SUMMARY OF CONCERNS IN RELATION TO THE PROPOSED NORTHCONNEX TUNNEL

This is an objection to many aspects of the proposed NorthConnex tunnel.

SECTION A: THE CONNECTIVITY OF NORTHCONNEX SOUTHERN VENTILATION FACILITY AT THE SOUTHERN INTERCHANGE, THE SOUTHBOUND TUNNEL IN PARTICULAR

MOTORWAY OPERATIONS COMPLEX - SOUTHERN VENTILATION FACILITY - SECTIONS
M1-M2-5000-DR-JD-0525

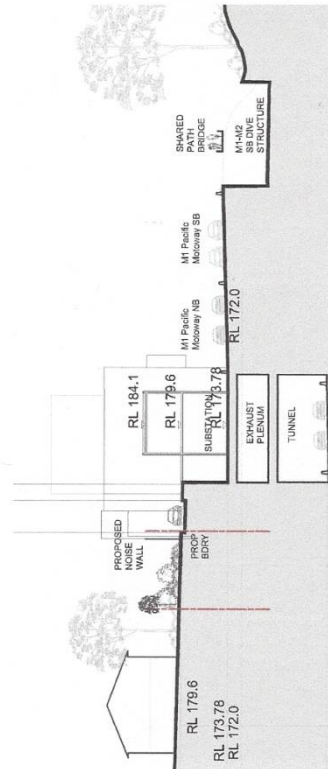
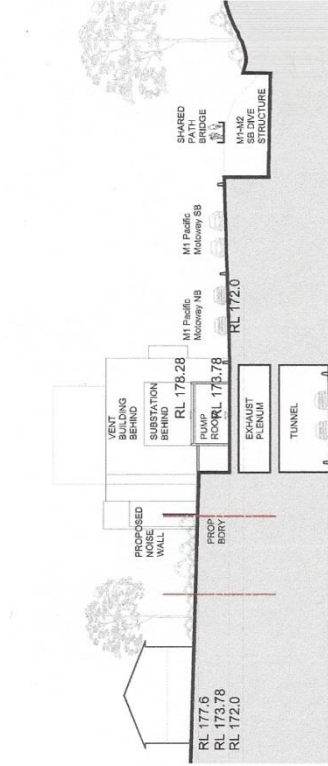
Page 8 below there is no indication of how the ventilation facility will be connected to either the northbound or southbound tunnel, nor is there any indication of how the southbound exit portal onto Pennant Hills Road or the south-west exit portal onto the M2 will be connected.

5. *EIS Volume 4, Technical working papers - Urban Design, 6.0 Operational Ancillary Facilities*
EIS Page 99 there is the diagram "Motorway Operations Complex – Southern Ventilation Facility – sections. *Page 10 below* The diagram has the cryptic label "Connection to tunnel TBC". What does TBC stand for? To be considered? Why is tunnel singular? Which tunnel is the diagram referring to northbound or southbound? There is no diagram showing any connection from the Southern Interchange ventilation facility to either the northbound or the southbound tunnel in any way AND YET

- Diagrams need to be provided showing the inter-relation between the shaft, the ventilation outlet and the motorway operations centre with a clear description of what is to be constructed and how it will operate.
- The community needs irrefutable evidence that the polluted air from the southbound tunnel exit portals will not be allowed to flow like an invisible sewer through West Pennant Hills, North Rocks, Carlingford and Beecroft.

M1-M2-5000-DR-UD-0556
NORTHERN VENTILATION FACILITY - LONG SECTION

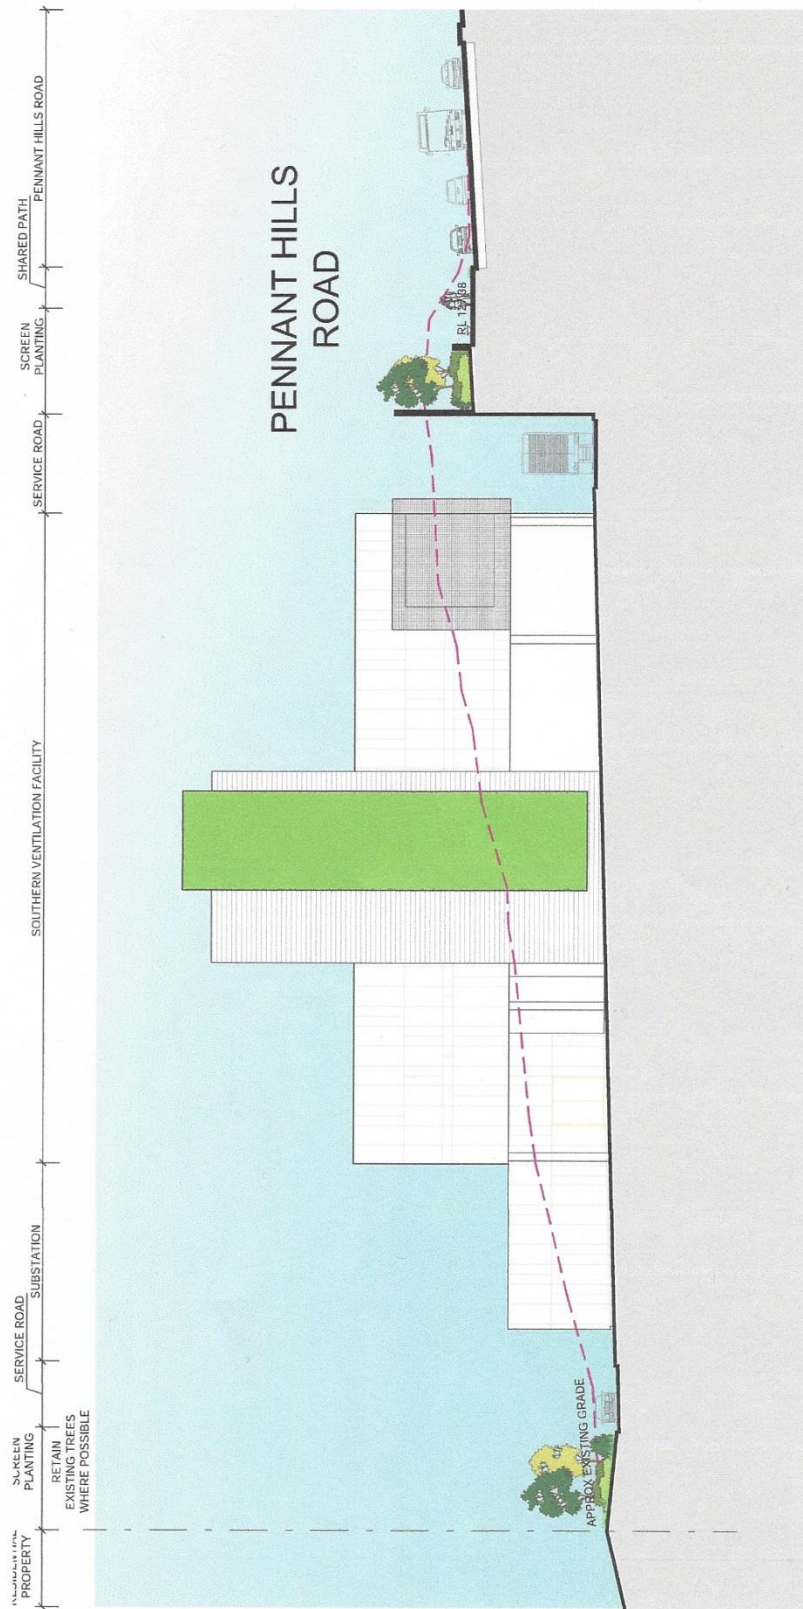
EIS page 134 *Page 12 below* there is a very explicit diagram showing the *Northern Ventilation Facility – long section*.

MOTORWAY OPERATIONS COMPLEX - SOUTHERN VENTILATION FACILITY - SITE SECTION 1-1
M1-M2-5000-DR-UD-0713

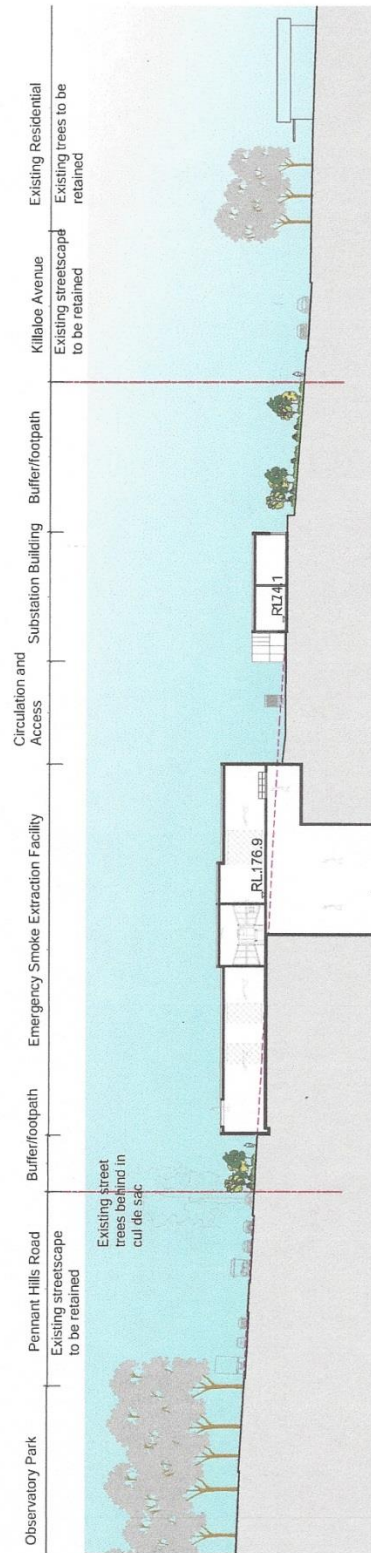
6. *EIS Volume 4, Technical working papers Urban Design, 8.0 Landscape Design*
EIS Page 176 is the diagram "Motorway Operations Complex – Southern Ventilation Facility – Site 1-1". *Page 13 below* The diagram does not show any connection to either the northbound or southbound tunnel. In the same Landscape Design section, EIS Page 182 is the diagram "Wilson Road Tunnel Support Facility –Section" *Page 14 below* which clearly shows the connection to the tunnels. In the same Landscape Design section, EIS Page 189 is the diagram "Northern Ventilation Facility – Landscape Concept Section". *Page 15 below* This also clearly shows the connection to the tunnels.
